SUBJECT: Responds to NRC Bulletin 88-04 re potential loss of safety related pumps.

Subject: Palo Verde Nuclear Generating Station (PVNGS)  
Units 1, 2 and 3  
Response to NRC Bulletin No. 88-04  
File: 88-A-056-026, 88-055-026

### ANPP RESPONSES TO NRC BULLETIN NO. 88-04

FIGURE 1 : SAFETY INJECTION SYSTEM

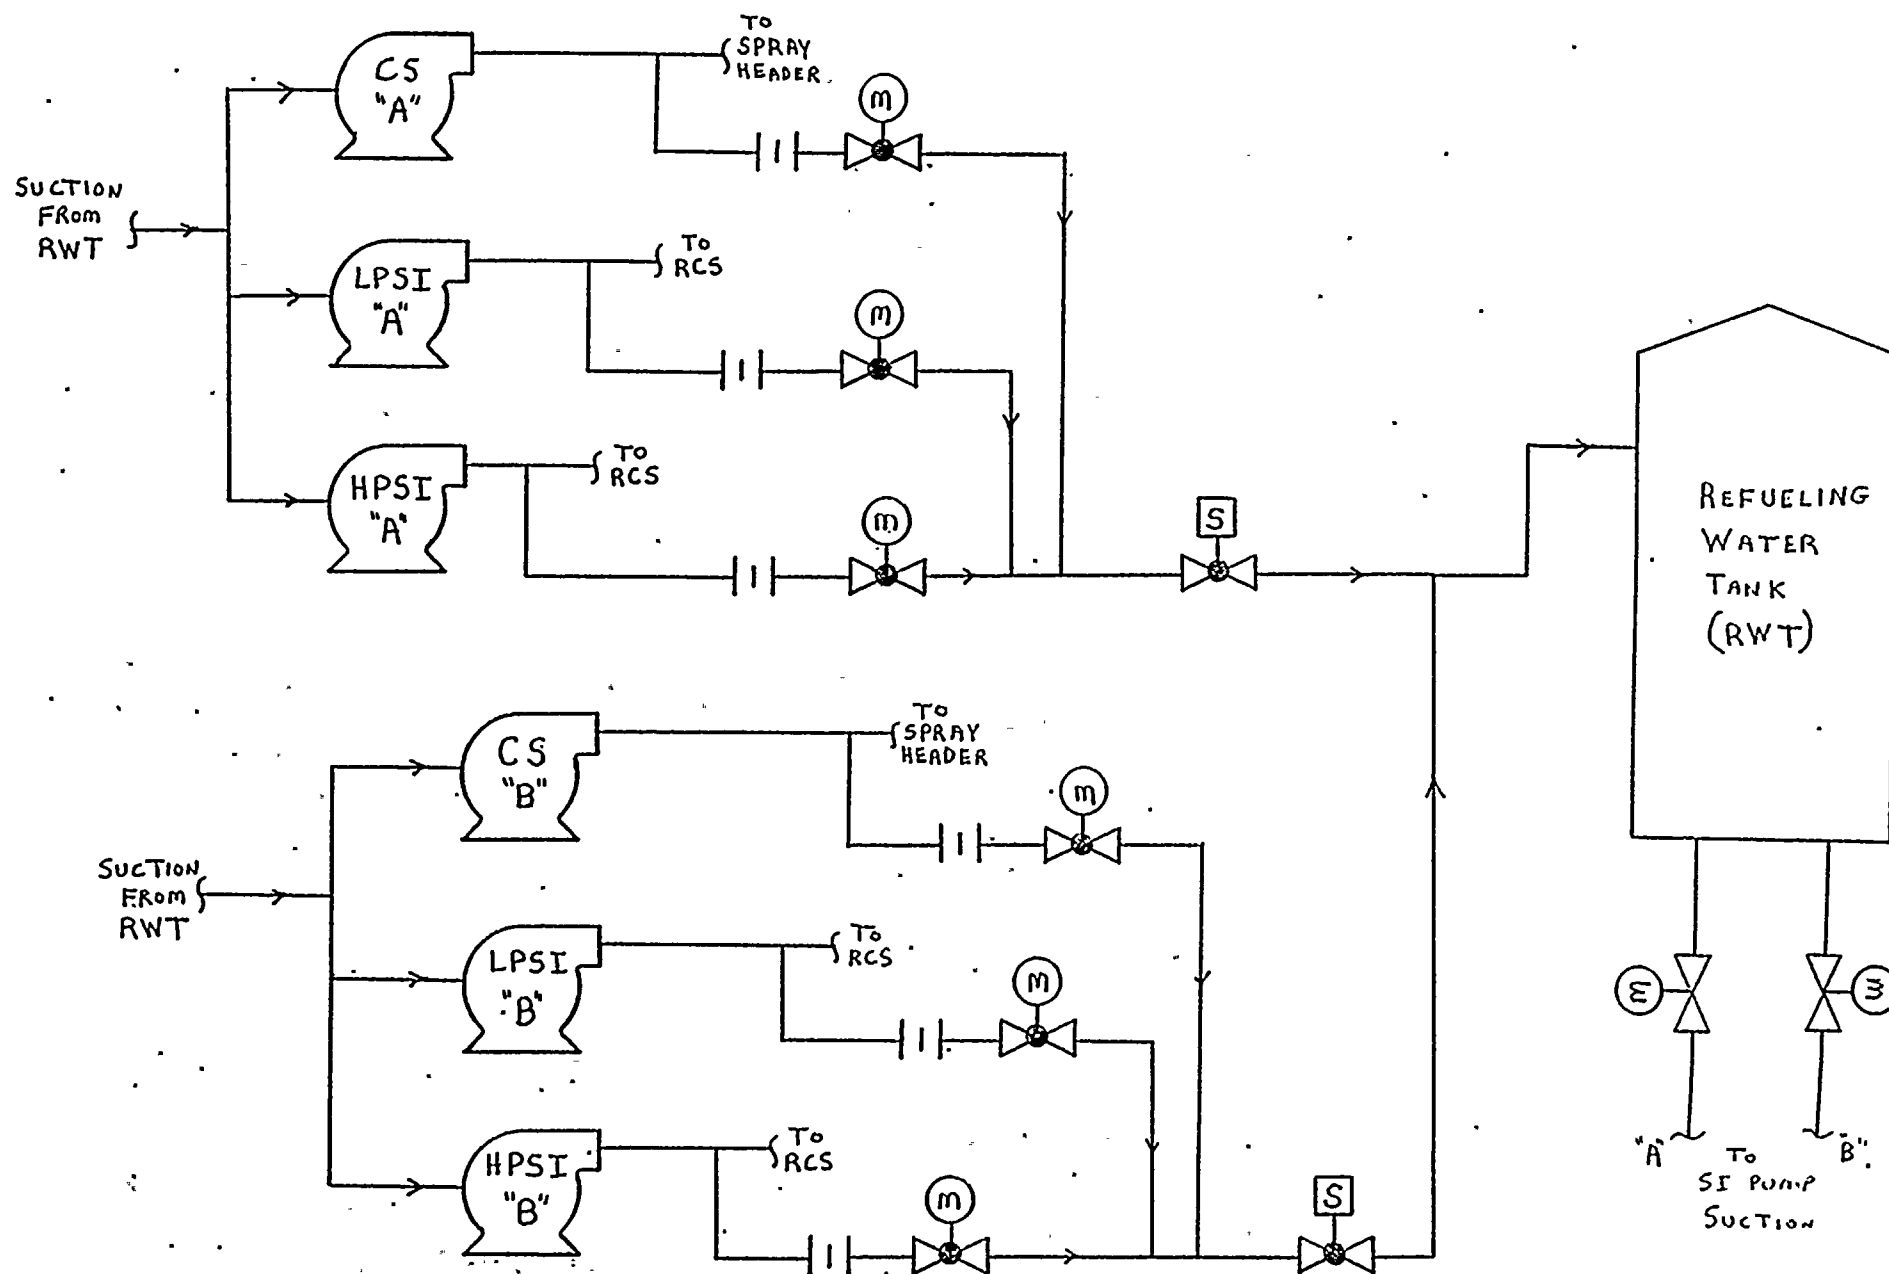
Promptly determine whether or not its facility has any safety-related system with a pump and piping configuration that does not preclude pump-to-pump interaction during miniflow operation and could therefore result in dead-heading of one or more pumps.

The safety injection system has two separate trains. Each train has a High Pressure Safety Injection (HPSI) pump, a Low Pressure Safety Injection (LPSI) pump, and a Containment Spray (CS) pump. A simplified schematic of the safety injection system is shown in Figure 1. As shown in the figure, all of the safety injection pumps take suction from the Refueling Water Tank (RWT). Each pump has an orificed minimum flow recirculation line. The flow orifice is located directly downstream of the pump. The flow orifice is followed by an automatic isolation valve. The isolation valve automatically closes when the system enters the recirculation mode of operation. The three minimum flow recirculation lines, associated with the three pumps of a single train, are joined into a common return header downstream of the automatic isolation valves. Another automatic isolation valve is provided on the common return header before the return header joins with the other train's return header. The recirculation flow then returns to the RWT. As an additional note, the recirculation piping increases in diameter as the individual pump recirculation lines combine into common headers. The recirculation lines begin as 2 inch diameter lines immediately downstream of the pumps. When the recirculation lines of three safety injection pumps join together, the common recirculation line increases to 4 inches in diameter. Finally, the common return header to the RWT is a 6 inch line.

For the safety injection system, ANPP has performed a calculation to evaluate the system for flow division. The calculation verified that the weakest pump (i.e., the lowest head pump) is capable of delivering its design recirculation flow when all six safety injection pumps are operating on minimum flow recirculation. The lowest head pumps in the safety injection system are the LPSI pumps. Furthermore, the Train B LPSI pump was selected for analysis since it has longer recirculation piping lengths than the Train A pump. Other significant features of the calculation are listed below:

- 1) Line and component resistances were calculated for the piping system based on startup test data and the as-built piping configuration.
- 2) The suction source (i.e., the RWT) was assumed to be at the minimum possible water level.
- 3) The highest recorded recirculation flow rates from Unit 1 startup testing were used. This maximizes the pressure drop in the recirculation lines.
- 4) For the weakest pump, the pump was assumed to be degraded to the required action level as per the ASME Section XI test requirements.
- 5) The effects of instrument error were accounted for. This further reduced the discharge head assumed in the analysis.

The calculation proved that the LPSI pump discharge head is more than sufficient to overcome the recirculation piping head losses. The design feature that significantly minimizes the potential for pump-to-pump interactions in the safety injection system is the dedicated orifices for each pump. Therefore, the potential problem of adverse pump-to-pump interactions during minimum flow recirculation operation is not a concern for the safety injection system.

FIGURE 2: AUXILIARY FEEDWATER AND CONDENSATE TRANSFER

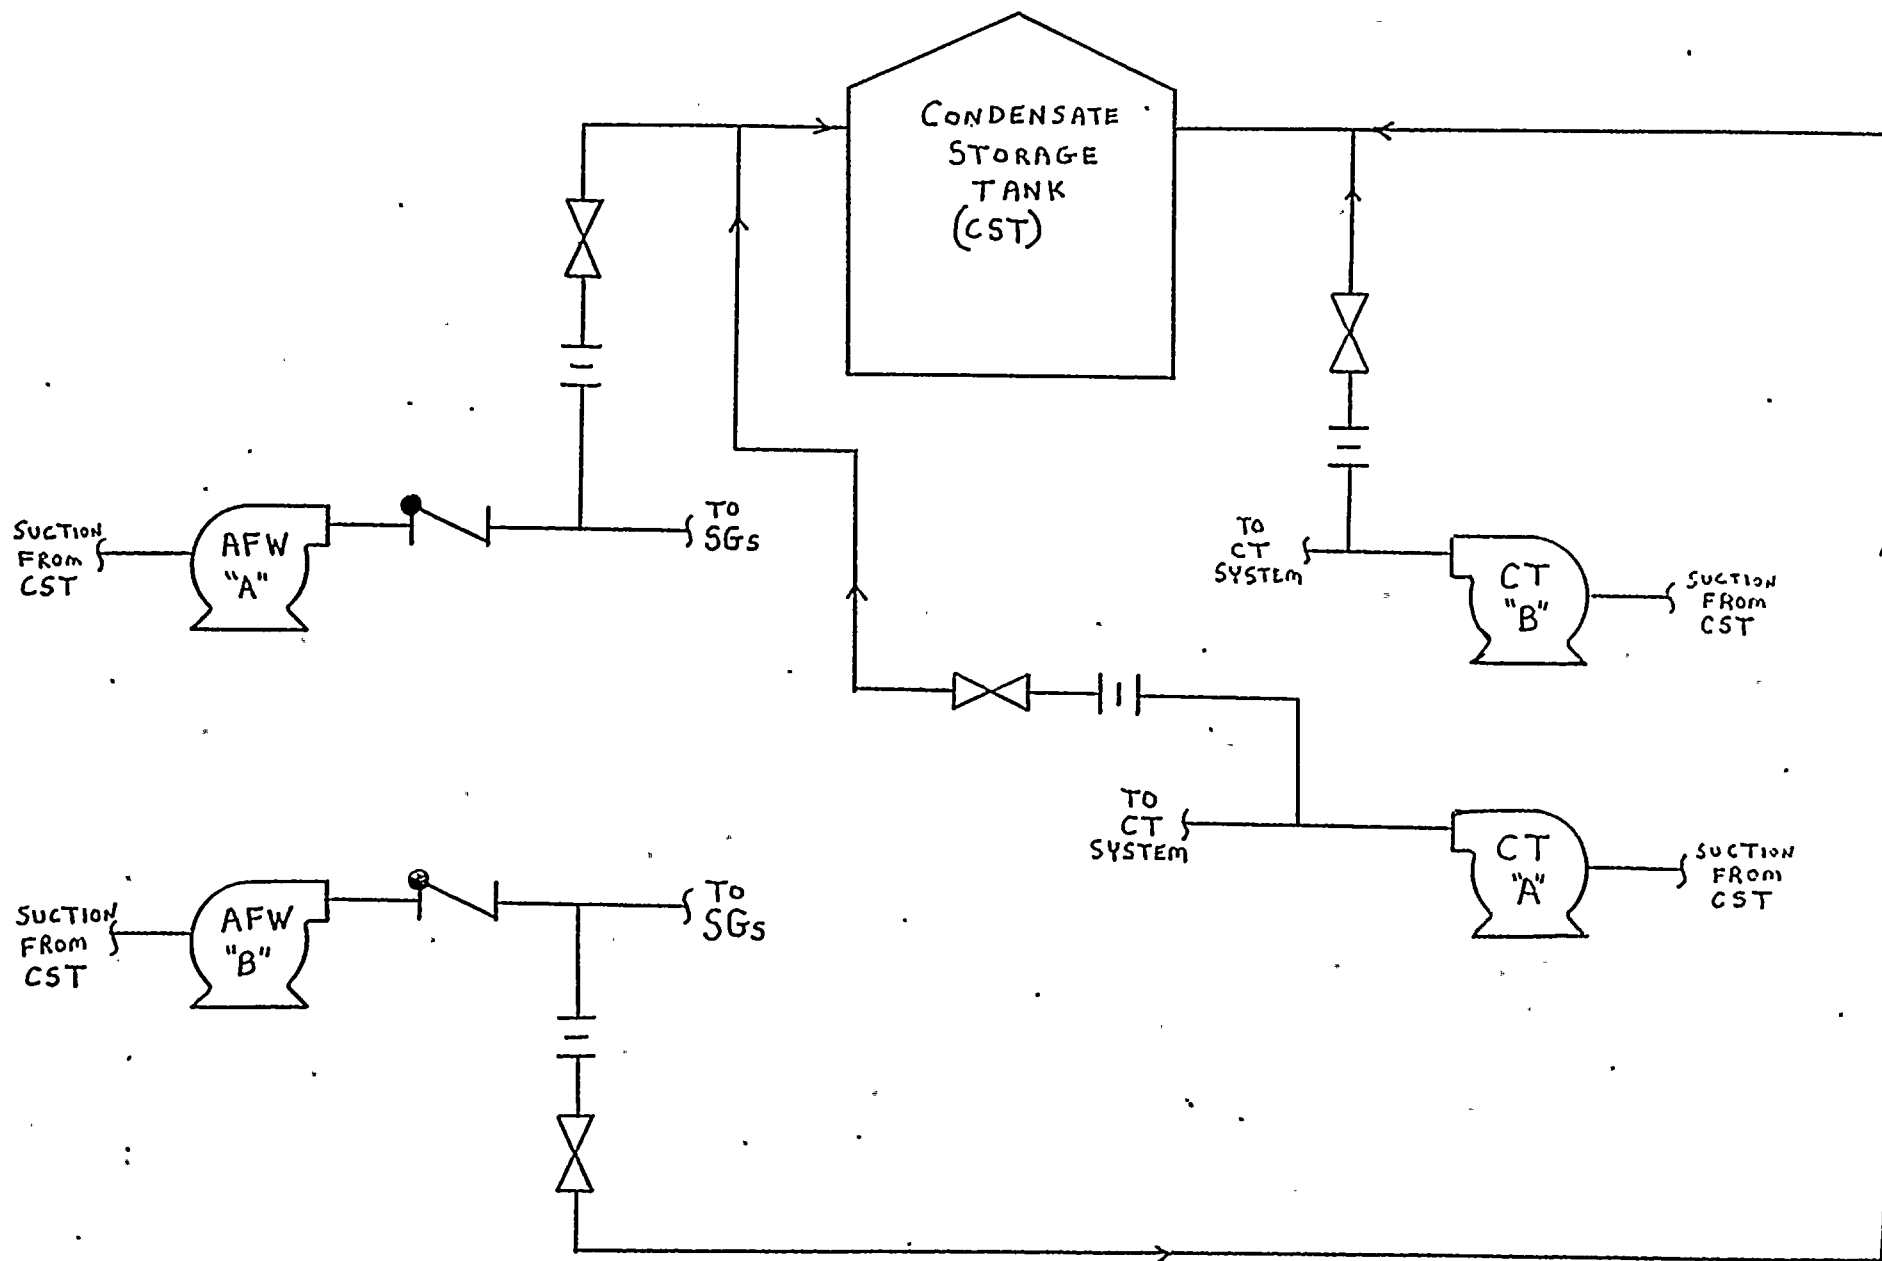
Figure 2 shows the condensate transfer pumps and the auxiliary feedwater pumps. There are two safety grade pumps in the condensate transfer system and in the auxiliary feedwater system. All of the pumps receive suction from the Condensate Storage Tank (CST). Each pump is equipped with an orificed minimum flow recirculation line that returns to the CST. A common return header is shared by the A-train condensate

transfer pump and the A-train auxiliary feedwater pump. A similar arrangement also exists for the B-train pumps. The recirculation lines for the auxiliary feedwater pumps are 6 inch diameter lines for most of the recirculation flowpath. The recirculation lines for the condensate transfer pumps are 1 inch diameter lines that expand to 3 inch lines prior to connecting with the auxiliary feedwater pump recirculation lines.

A similar calculation was performed for the common recirculation lines of the condensate transfer and auxiliary feedwater pumps. For the analysis, the weakest pump was selected. In this case, the condensate transfer pumps were selected as the weakest pumps since they have a

design head of 61 feet as opposed to a design head of 3280 feet for the auxiliary feedwater pumps. Some of the key features of the calculation are listed below:

- 1) The suction source (i.e., the CST) was assumed to be at its empty level setpoint.
- 2) Line and component resistances were calculated based on the as-built piping system configuration.
- 3) The associated auxiliary feedwater pump was assumed to be operating with a recirculation flow rate of 260 gpm. The as-built recirculation flow rates for the auxiliary feedwater pumps in the three PVNGS units range from 240 to 260 gpm. For this calculation, the maximum value of 260 gpm was used. This results in conservatively high pressure drops.
- 4) The condensate transfer pump was assumed to be degraded to the required action level per the ASME Section XI test requirements.
- 5) Instrument error was assumed to further reduce the assumed pump performance.

The results of the calculation show that the condensate transfer pumps are capable of maintaining a recirculation flow rate of 26.3 gpm under these worst case conditions. Note that this flow rate is slightly less than the current design recirculation flow rate of 30 gpm. ANPP does not believe that this reduced recirculation flow rate impacts pump operation. The reduced flow rate is approximately 20% of the pump's output. Additionally, the reduced flow rate exceeds the vendor's original recommended minimum recirculation flow rate of 10%. The pump vendor has also been asked to evaluate the condensate transfer pumps and to provide the minimum acceptable recirculation flow rates based on the NRC's identified concerns (refer to question 3). Once the vendor input is received, the worst case recirculation flow rate of 26.3 gpm will be compared with the vendor's recommendation.
